Access Compliance Report

Public Rights-of-Way

(Pedestrian Signals)

Intersection ID: N/A	Main Street:	Cross Street: N/A	Location: N/A
ADA ID: EBF274E1A21E	Signal Type: One Push Button-Non APS	Overall Compliance: No	Severity Score: BTN 1: N/A BTN 2: N/A No BTN: N/A
Codes/Mitigation Info/Possible Solution		Field Measurements/Component Compliance

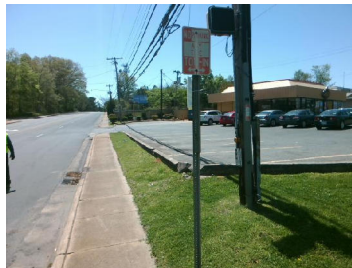
PROW/ADA: TMUTCD 4e.08, R404.2, R404.3, R404.7.1, R404.7.2

Possible Solutions: Replace Signal Push Button With APS Button on New Post. Remove & Relocate Sign.
